City of Lafayette Staff Report

For: Planning Commission
By: Greg Wolff, Senior Planner
Date Written: March 28, 2006
Meeting Date: April 6, 2005
Subject: **HDP38-05 THOMAS & DONNA AMEN (APPLICANTS & OWNERS) LR-10 ZONING:** Request for a Hillside Development per section 6-2015 of the Lafayette Municipal Code to establish a building site for the future construction of a single family residence at 3315 Hillside Terrace. APN 230-030-065
Statutory Deadline: July 3, 2006 (with PSA extension)

Lafayette Area Ridge Map

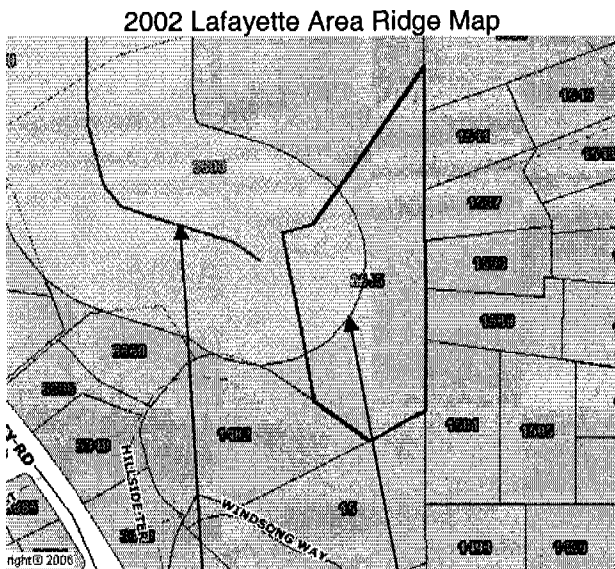
The administrative record shows that the Design Review Commission, Planning Commission and staff concluded that the "Hillside Terrace Ridge" extends across the site from the

northwest to the southeast, terminating off site somewhere in the vicinity of the Duffy residence.

Class II Ridgeline • 250-ft. Setback

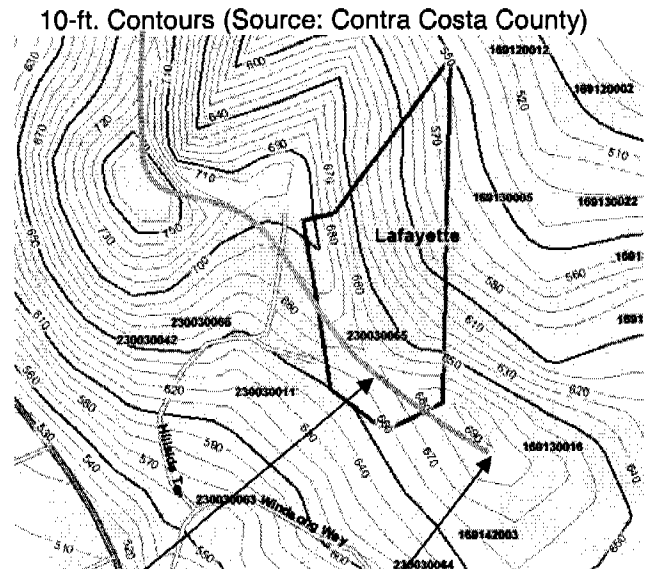
Site specific topography currently submitted by the applicant supports the City's initial finding that the ridge crosses the property from the northwest to the southeast, terminating off site. This is consistent with 10-ft. contour topography available from Contra Costa County.
